ATTACHMENT 5

Letter from M. E. Warner (NMC)

License Amendment Request 187

Revised Pages for Updated Safety Analysis Report
(USAR)

Figure 14.1.8-3

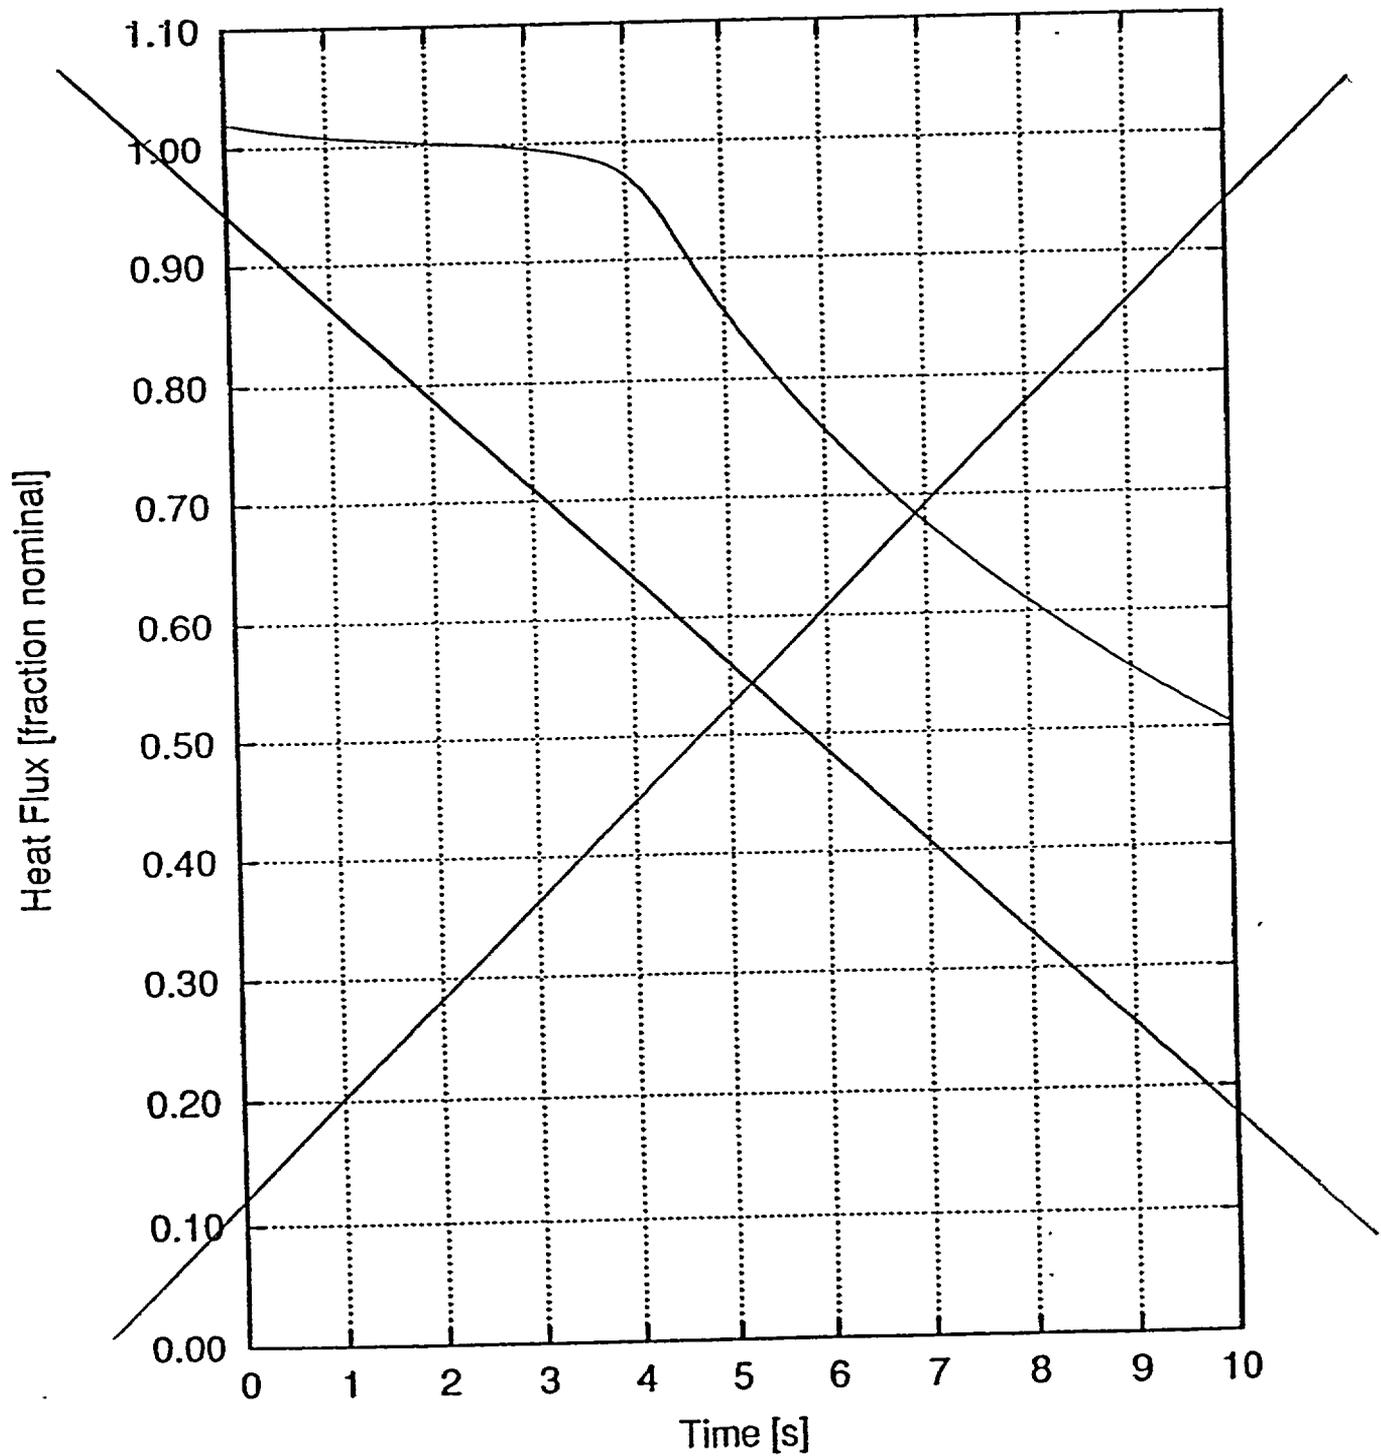
REPLACE WITH NEW FIGURE 14.1.8-3

Figure 14.1.8-4

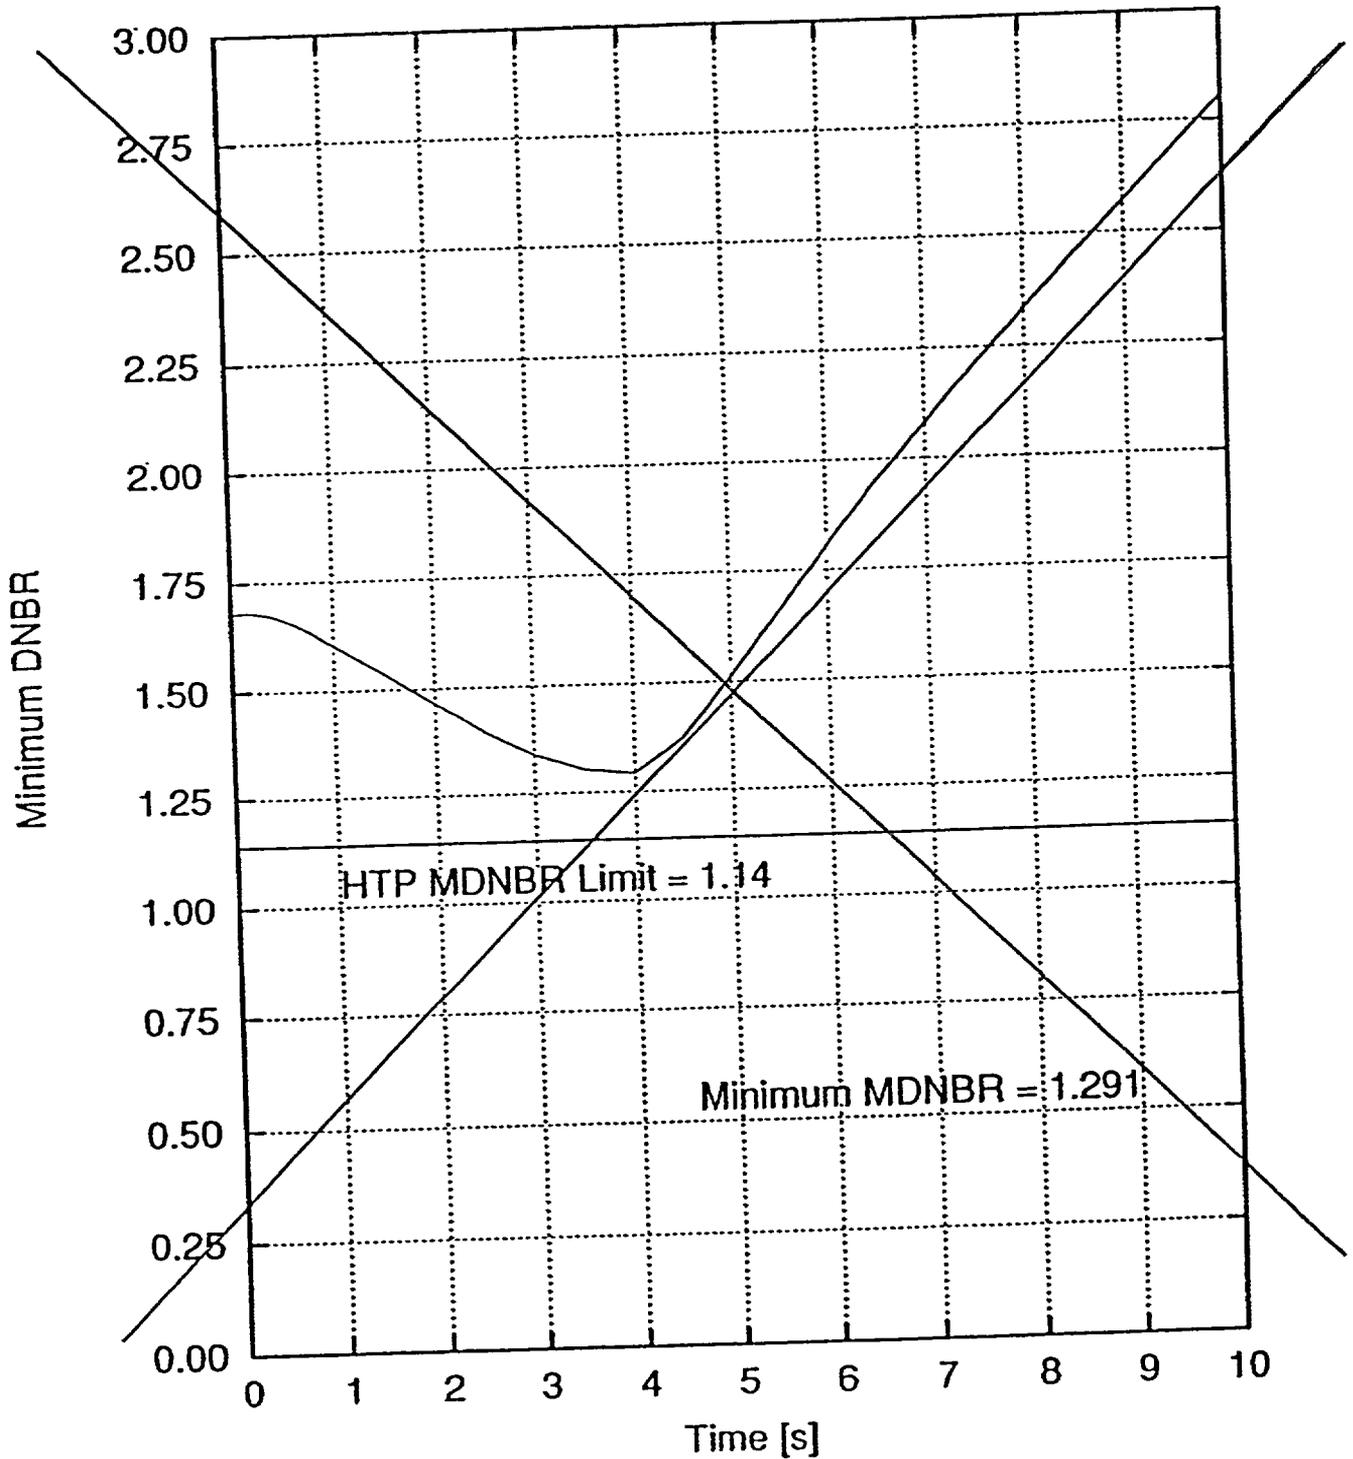
REPLACE WITH NEW FIGURE 14.1.8-4

Figure 14.1.8-5

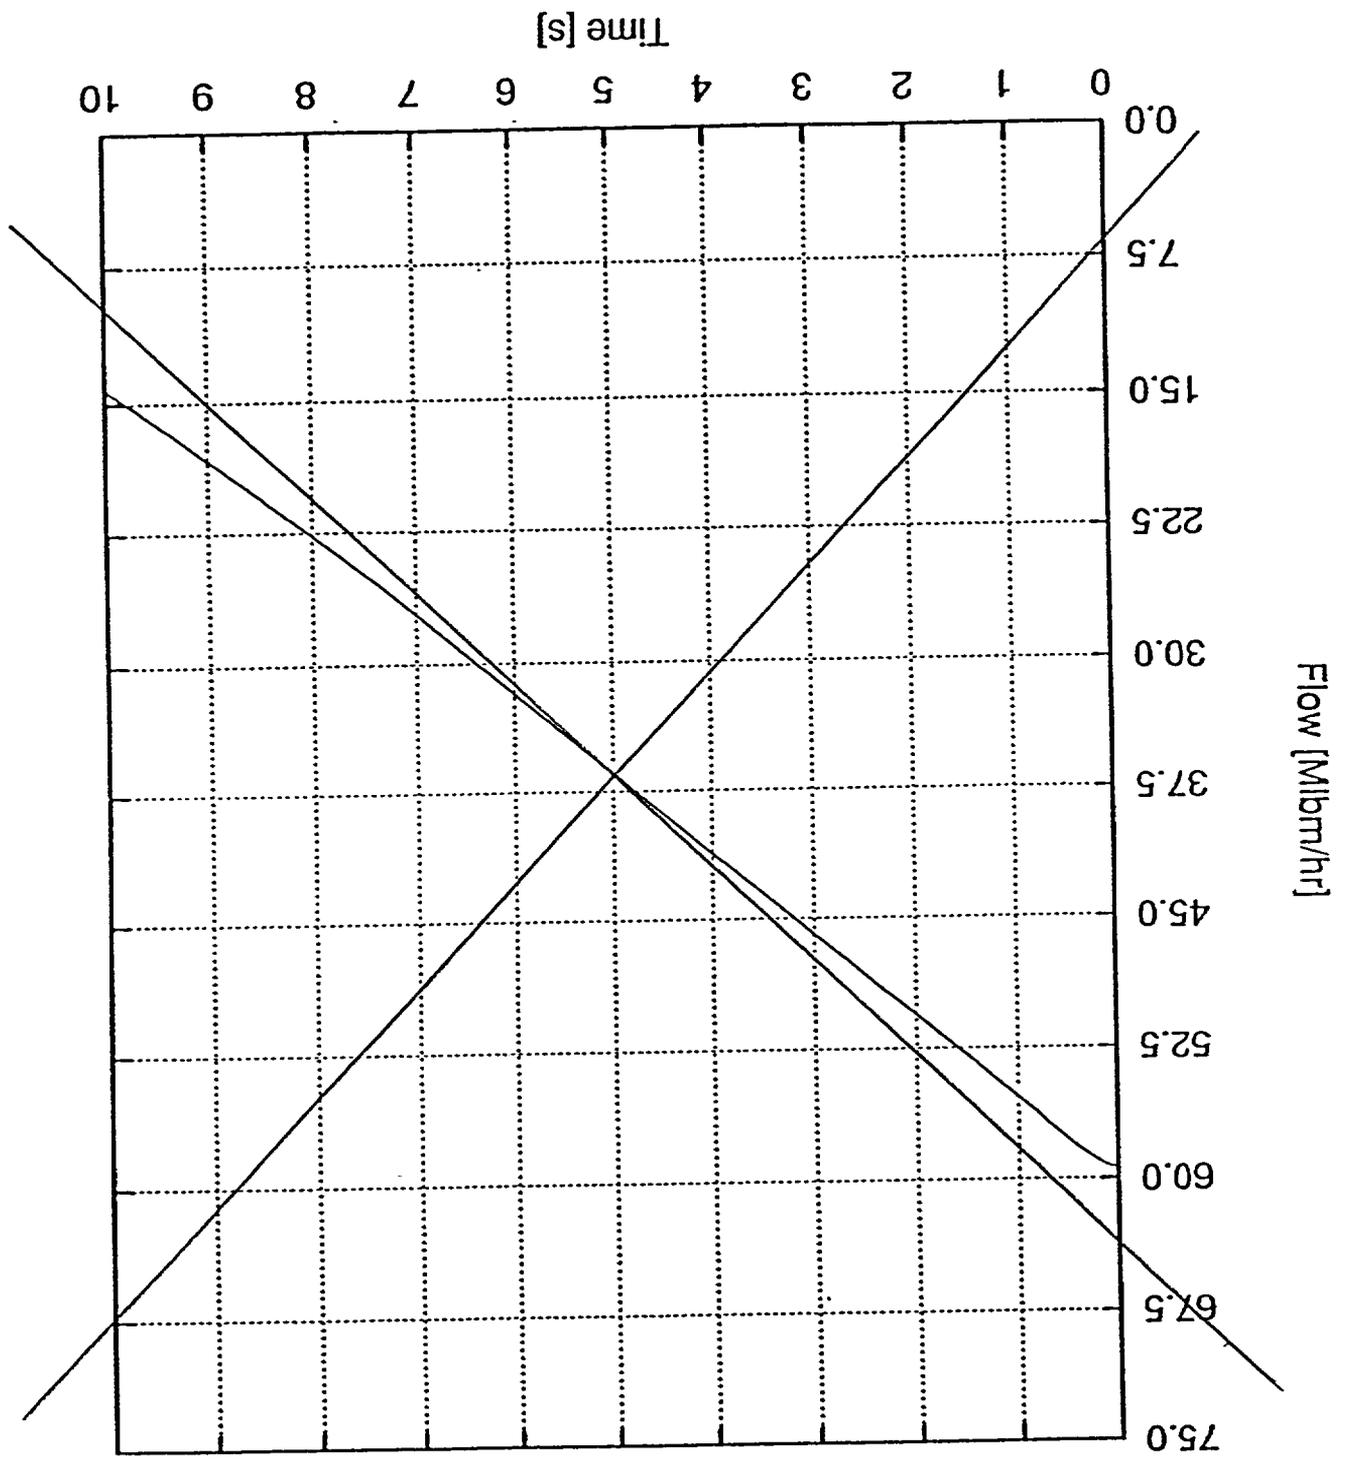
REPLACE WITH NEW FIGURE 14.1.8-5

Figure 14.1.8-6

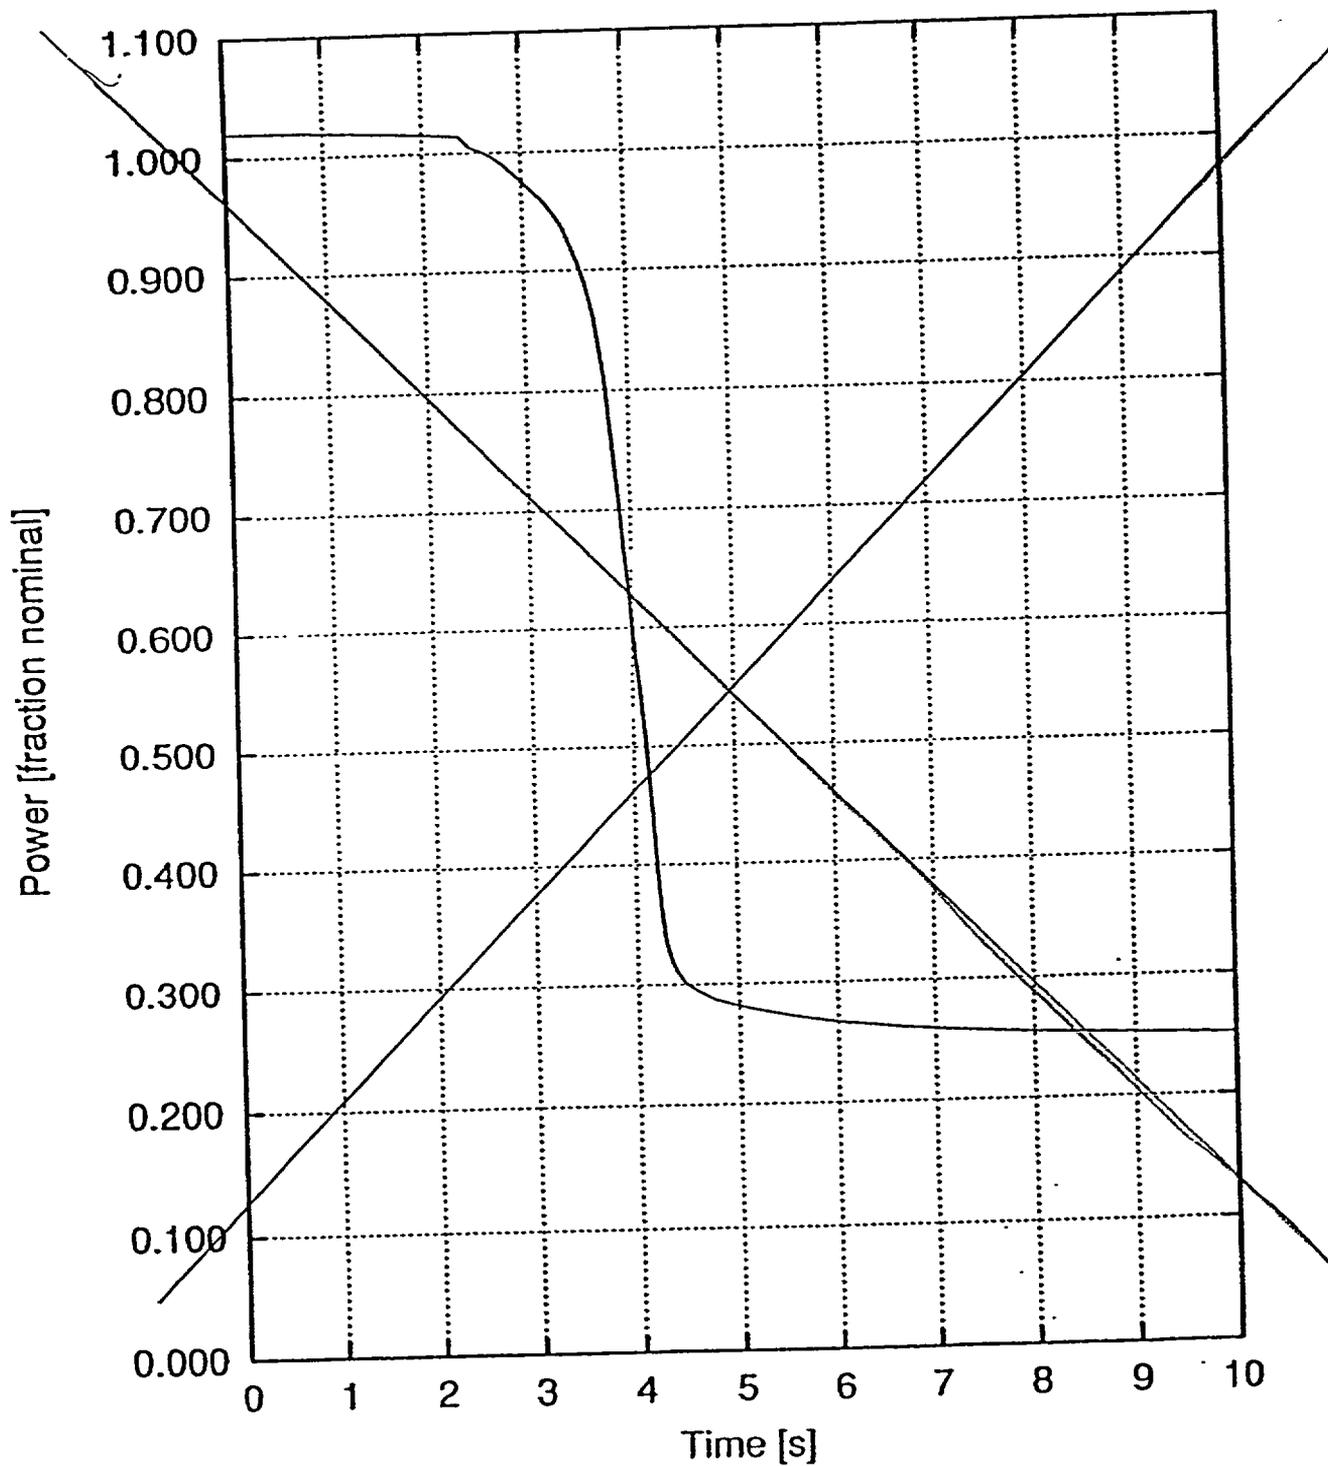
REPLACE WITH NEW FIGURE 14.1.8-6

Figure 14.1.8-7

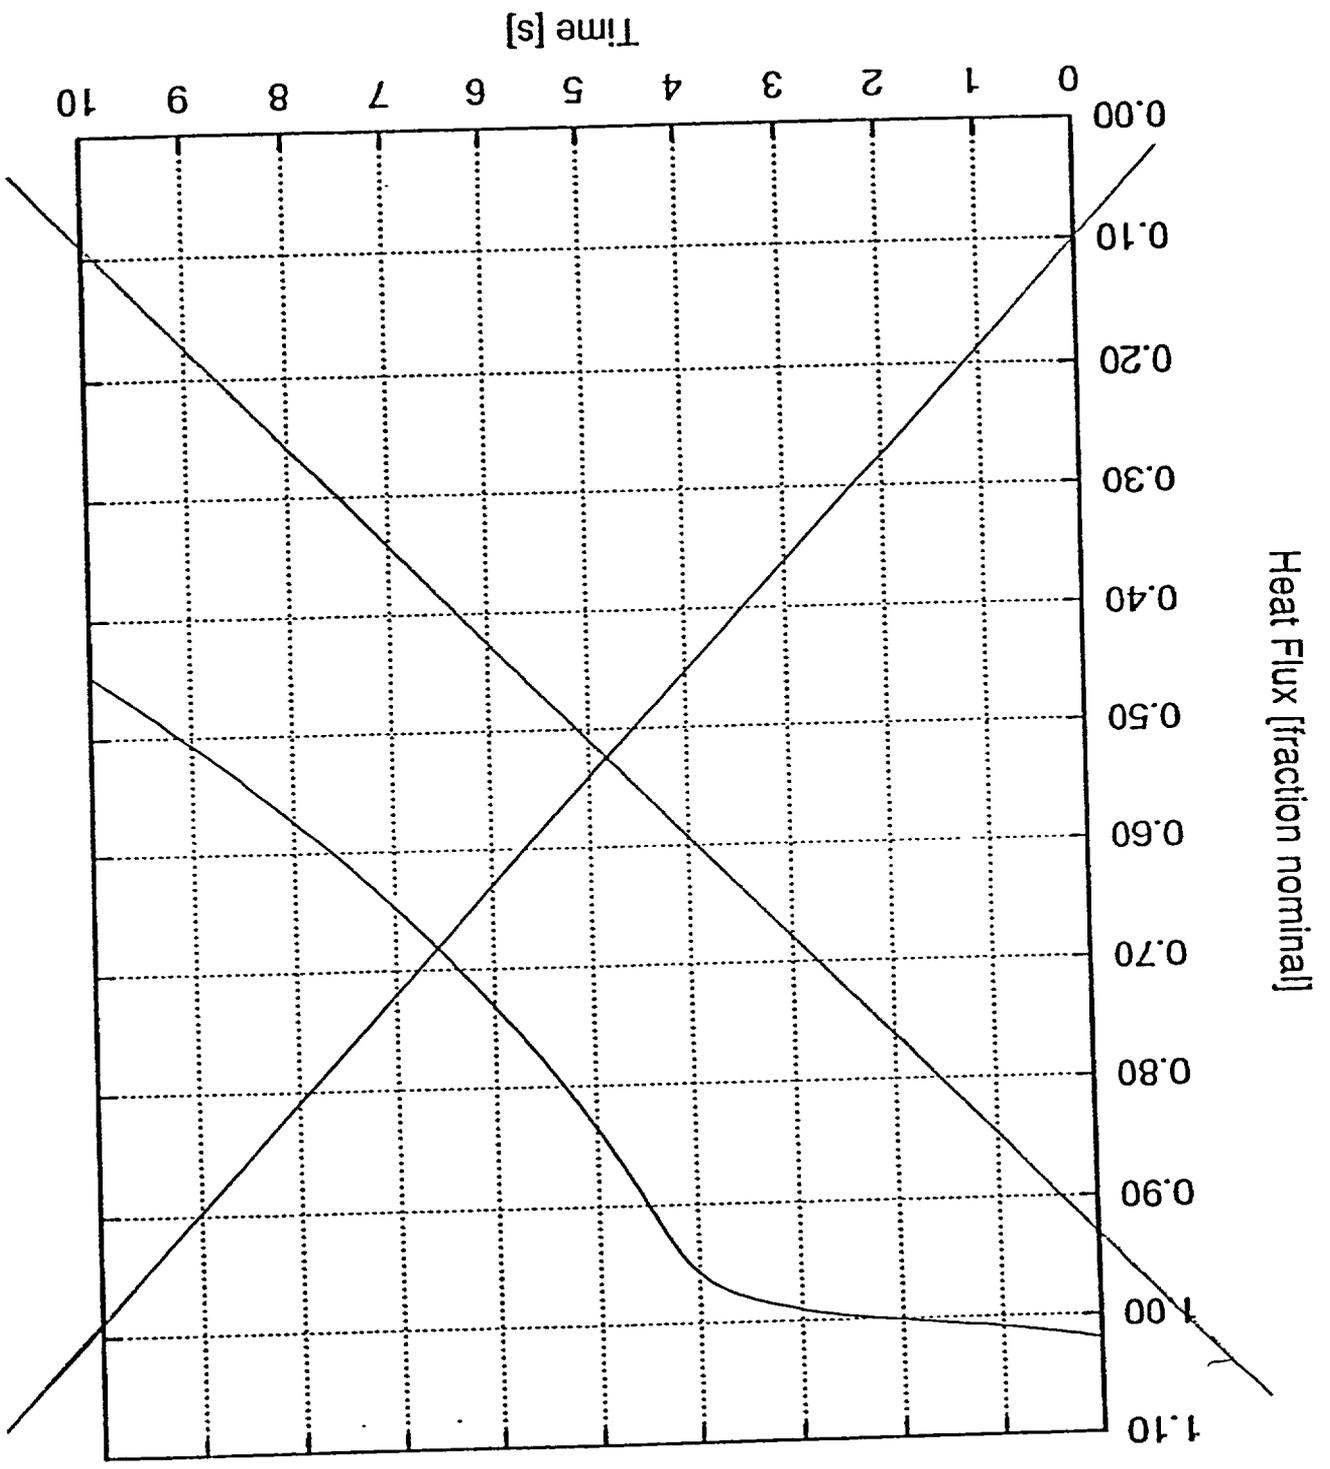
REPLACE WITH NEW FIGURE 14.1.8-7
